Re: San Roque & La Serena
441 & 457 Coors Blvd. NW
Traffic Circulation Layout
Engineer's Stamp 09-25-23 (J10-D049)

Based upon the information provided in your submittal received 09-25-23, the above referenced plan cannot be approved for Building Permit until the following comments are addressed:

Conceptual Traffic Circulation Layout
c5.0

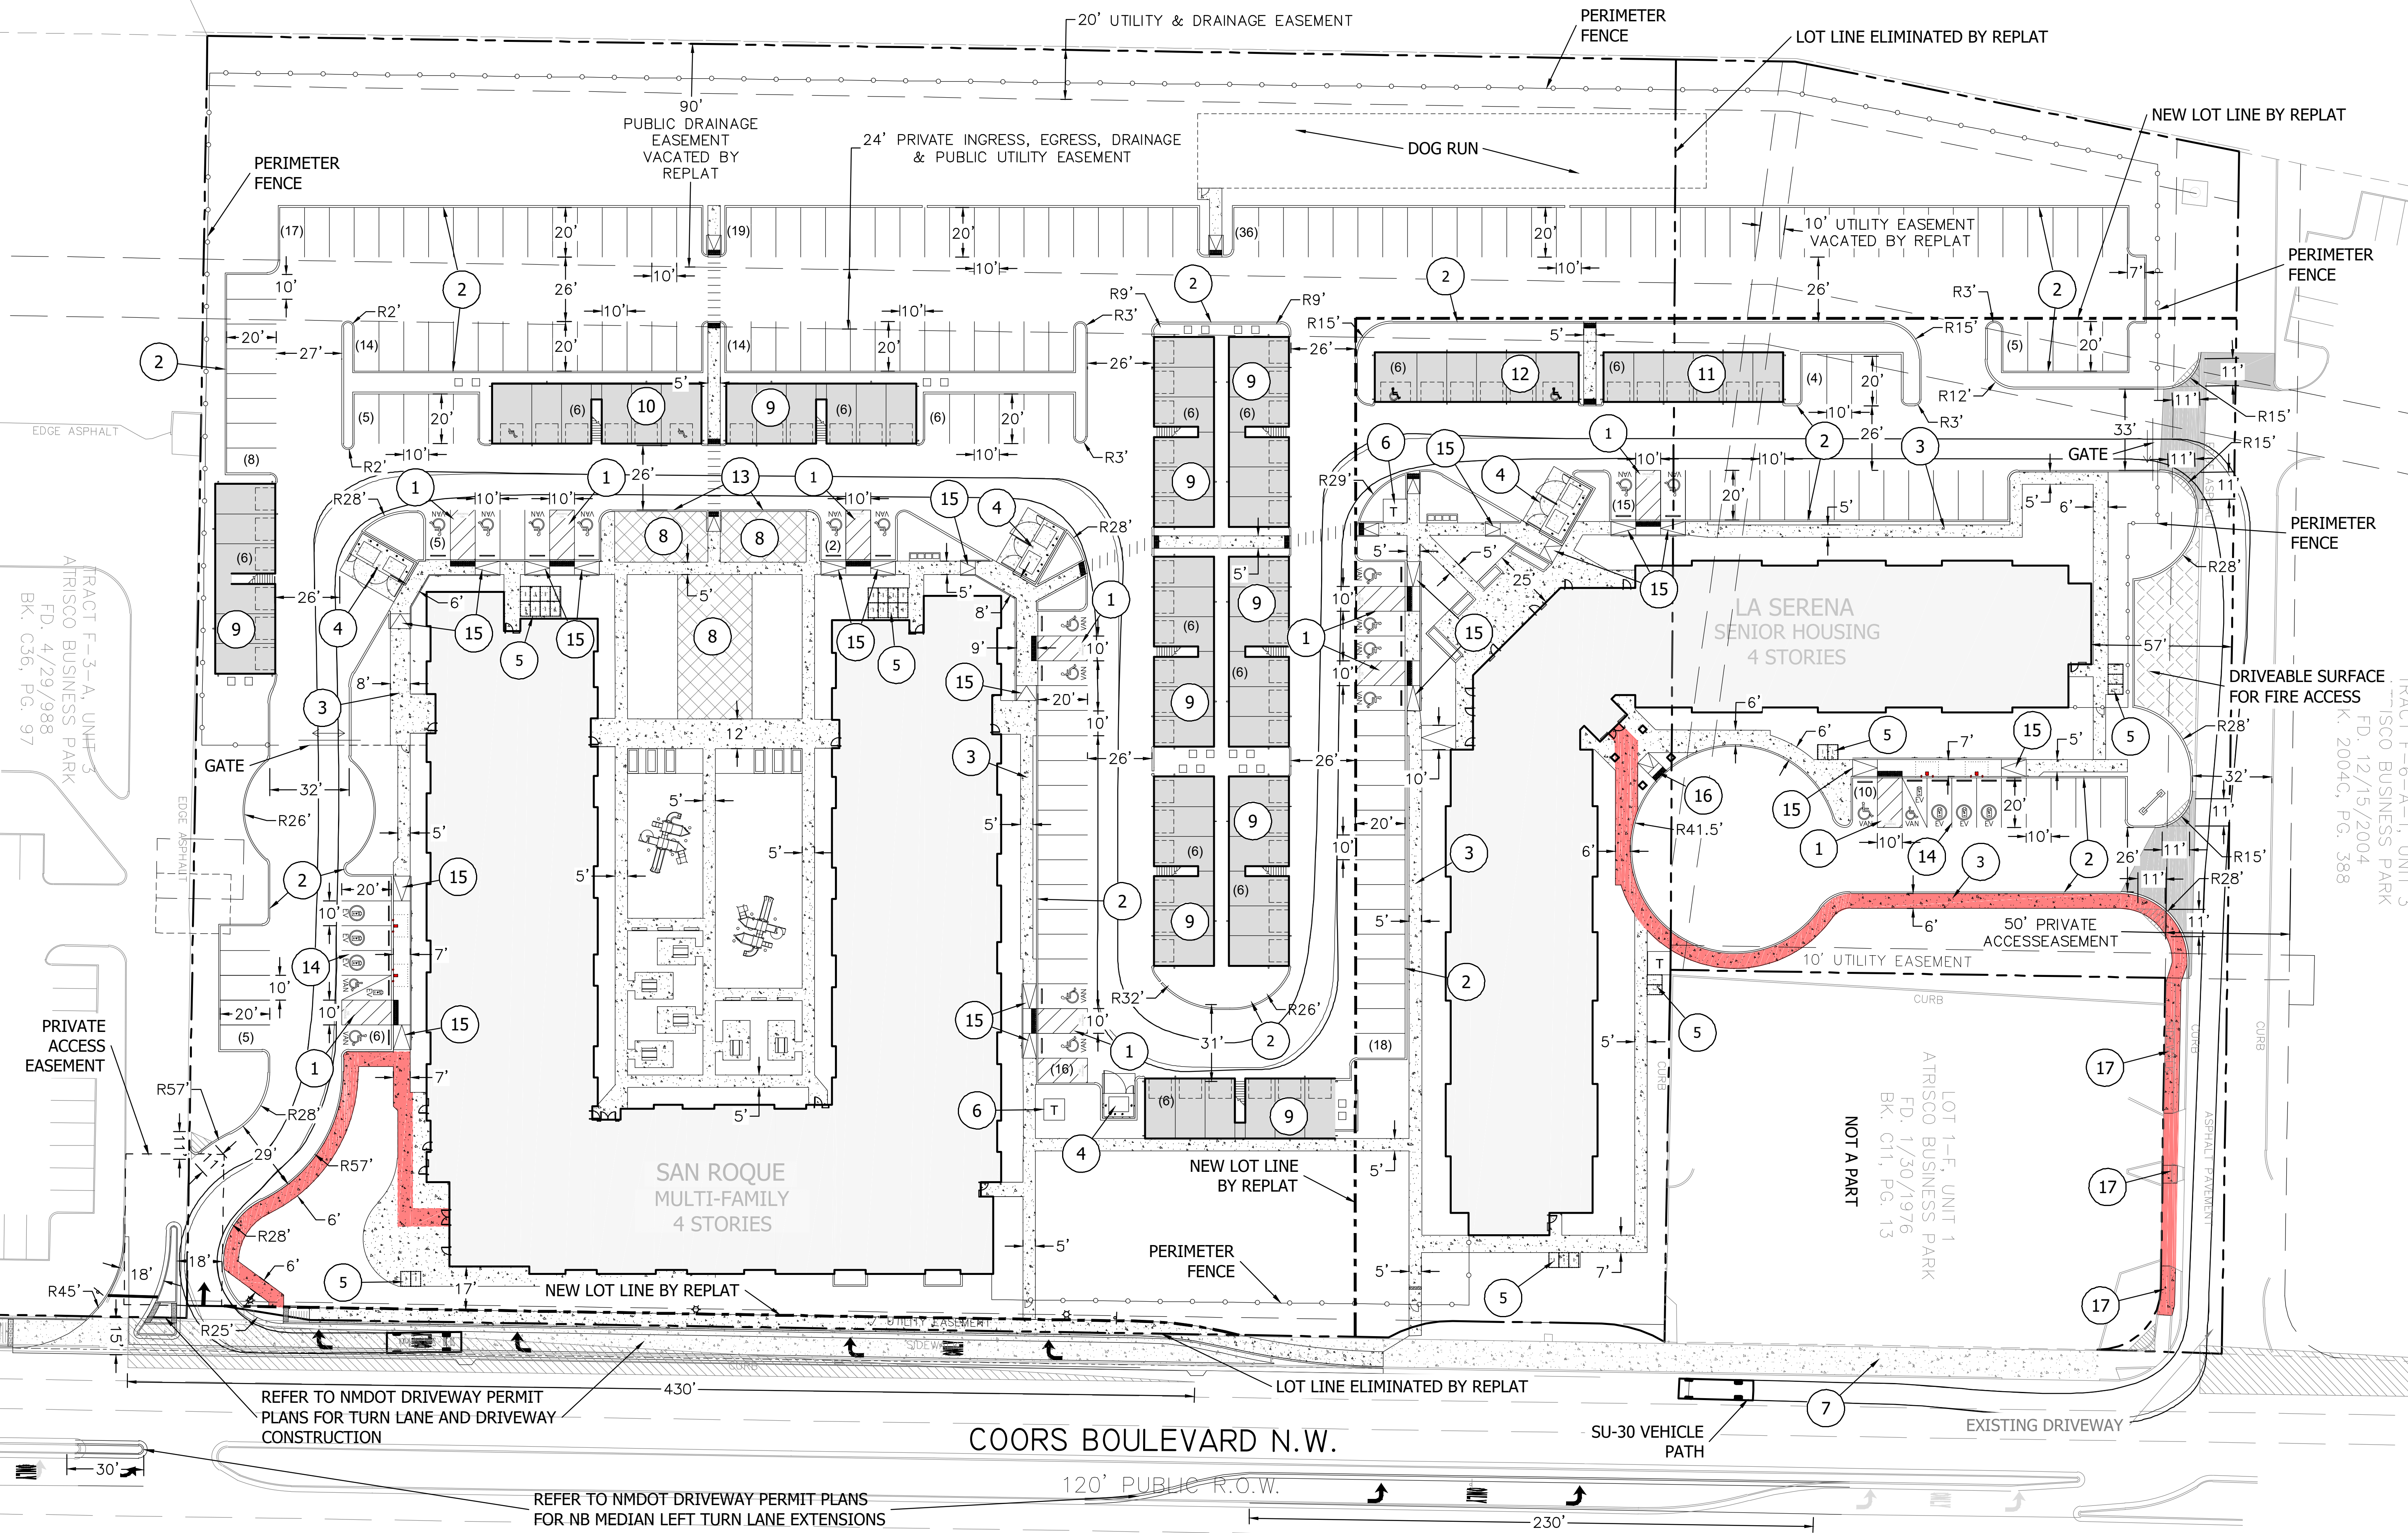
1. NMDOT Approval for the proposed turn lane and driveway access off Coors Blvd. is required prior to approve this TCL.
2. List the number of Motorcycle parking spaces required by the IDO
3. Identify all existing access easements and rights of way width dimensions.
4. Please provide an approved plat showing the shared access easement.
5. Sidewalk must be improved from property line to property line at the north side of the site.
6. Site accesses at the north side of the site must be built per ADA city standard and have Truncated Domes installed.
7. Please show on the site plan this drive aisle width and this ADA rout width.

8. Motorcycle parking spaces shall be designated by its own conspicuously posted upright sign, either free-standing or wall mounted per the zoning code.
9. The pavement marking "MC" should be shown in the opposite direction for motorcycles entering the parking space.

10. Please provide Bike Rack details. Details sheet C7.0 and C7.1 are missing.
11. All bicycle racks shall be designed according to the following guidelines:

15. Per DPM, a 6 ft. wide ADA accessible pedestrian pathway is required from the ADA parking stall access aisles to the building entrances. Please clearly show this pathway and provide details.

16. ADA accessible pedestrian pathway should not be placed behind parking space or adjacent to a vehicular way. Vehicle and pedestrian/wheel chair conflicts should be avoided as much as possible.

17. All sidewalks along streets should be placed at the property line.
18. Refuse vehicle maneuvering shall be contained on-site. The refuse vehicle shall not back into the public right of way.; provide a copy of refuse approval.

19. Provide a copy of Fire Marshal approval.
20. It is not apparent what type of pavement surface is being proposed. A hard driving surface will be required as part of this proposed project for parking area and drive aisles.
